ADDENDUM #1 TO BID #21-029

BID NUMBER: 21-029

PROCUREMENT FOR: Waverly Park

ADDENDUM 1 DRAWING A

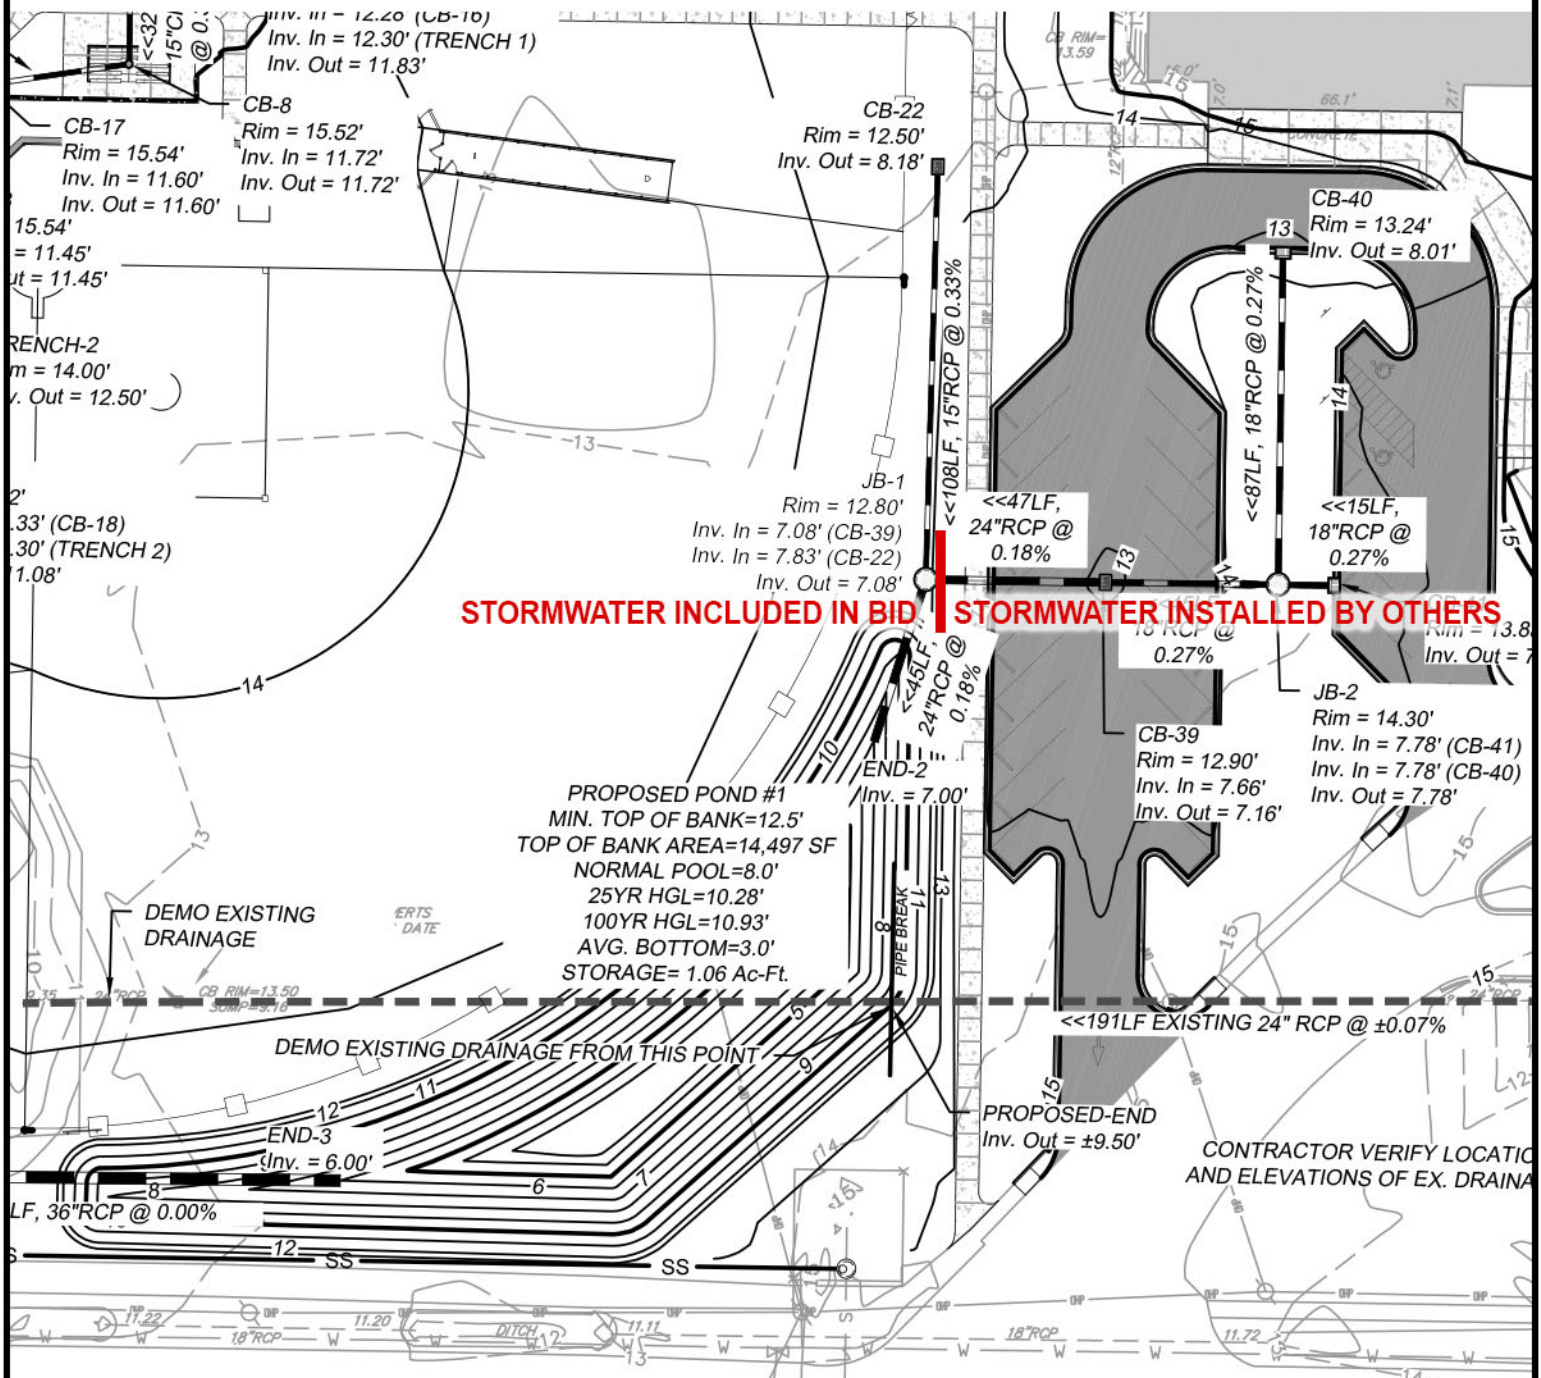
Question #2: Please provide more info regarding Alternates #3 and #4. Specifically, which sidewalk is included in the base bid and where does the alternate sidewalk start/end?

Response: Please see attached “Addendum 1 Drawing A” showing sidewalk limits for Base Bid, Alternate 3 and Alternate 4.
